San Joaquin Solar 1 & 2 Hybrid Project

Complete Response to CEC Data Request

Set #1, 08-AFC-12

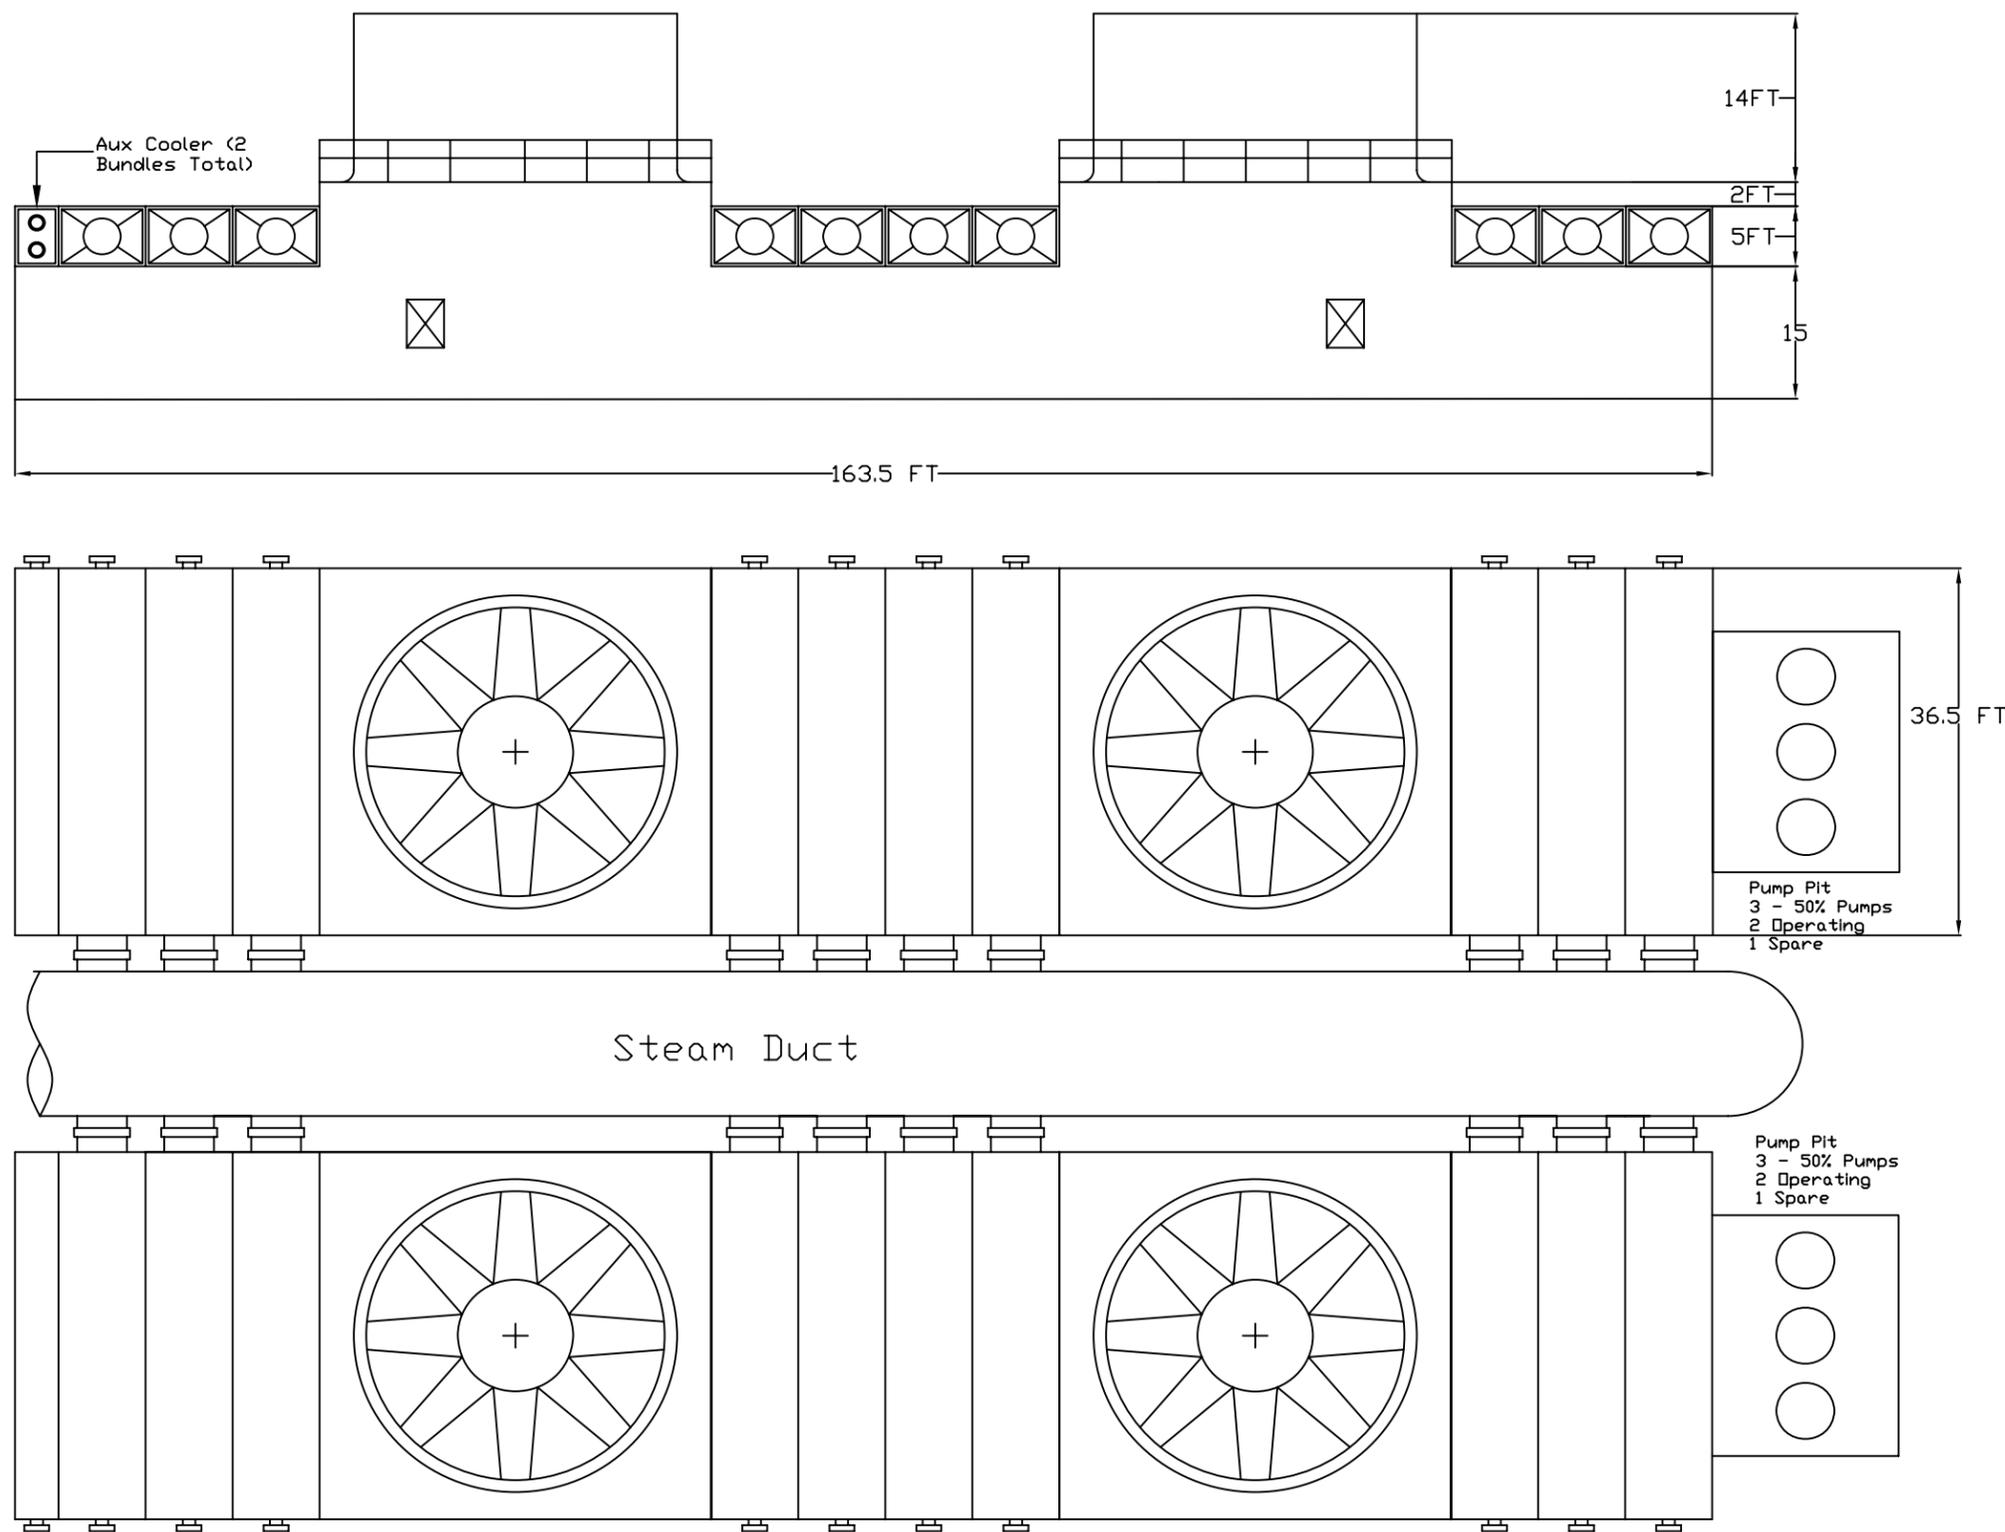
Data Request 138: Please provide the cooling tower manufacturer and model number information and a fogging frequency curve from the cooling tower vendor, if available.

Response: WSAC Unit is a 2 cell Niagara unit, model No. RVC 89833-2F26. Each steam turbine requires one 2 cell WSAC unit, each cell has two fans. A fogging frequency curve is not available.
